**From:** Christopher Buckley <cbuckleya1cp@att.net>  
**Sent:** Monday, October 7, 2019 11:19 PM  
**To:** 'Heather Coleman'  
**Cc:** Allen Tai; ANDREW THOMAS; Henry Dong  
**Subject:** RE: Objective Multifamily Design Review Standards - -Markups of existing documents and possible additional provisions (3 of 3)  
**Attachments:** 2019-10-4WebsterStreetDesignManualMarkUps.pdf

COMBINE WITH VARIOUS SECTIONS OF  
WEBSTER STREET DESIGN MANUAL, CITYWIDE DESIGN REVIEW MANUAL  
AND GUIDE TO RESIDENTIAL DESIGN. SEE MARKED-UP SELECTIONS  
FROM THESE DOCUMENTS. 10/4/19

# Objective Design Review Standards for Multi-family Residential Development

## Surface Materials

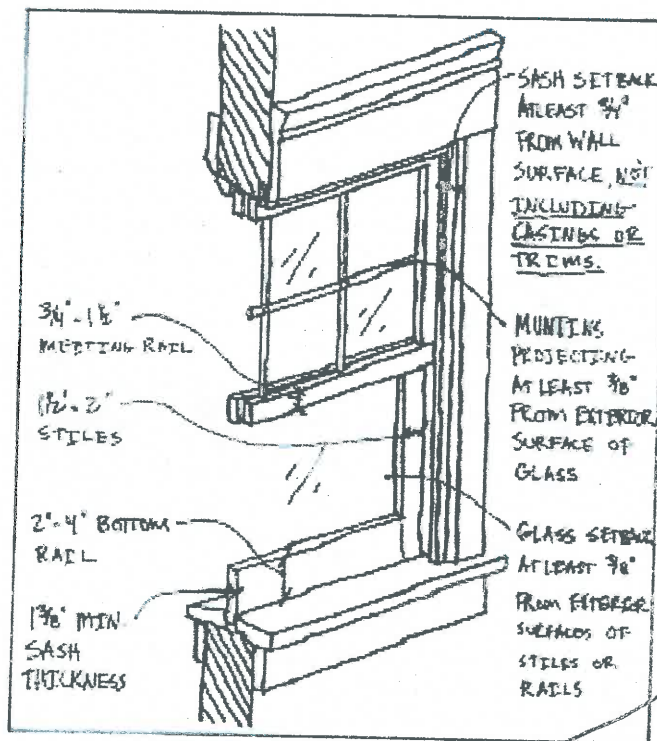
and other dimensions consistent with those shown in the above diagram.

## Storefronts

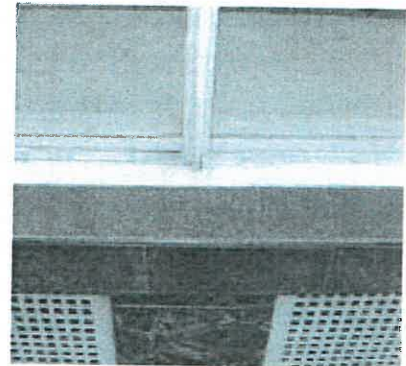
6.11 For tile, stone or brick bulkheads, either: *within 1" of*

- set the storefront windows at or ~~near~~ the face of the bulkhead; or
- incorporate the bulkhead material into the sill detailing.

Guideline 6.18a (left): **Discouraged** - Avoid informal or rustic materials like rough stone or common brick.

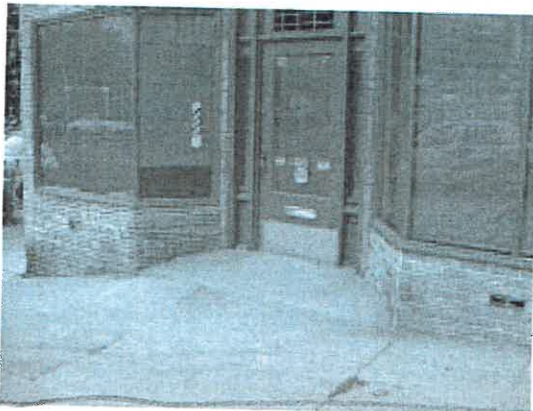
6.19 <sup>Do not use</sup> Stucco is usually discouraged as a bulkhead material. In limited cases where the overall façade and style of building displays stucco, its use as a bulkhead material may be appropriate.

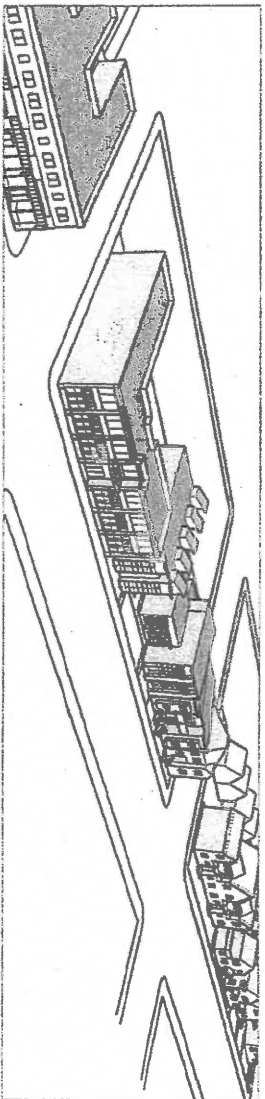
NOTE: "BUILDING TYPE" PROGRAMS IDENTIFIED FOR INCLUSION IN THE ODES ARE INDICATED BY A STAR TO ALL BUILDING TYPES
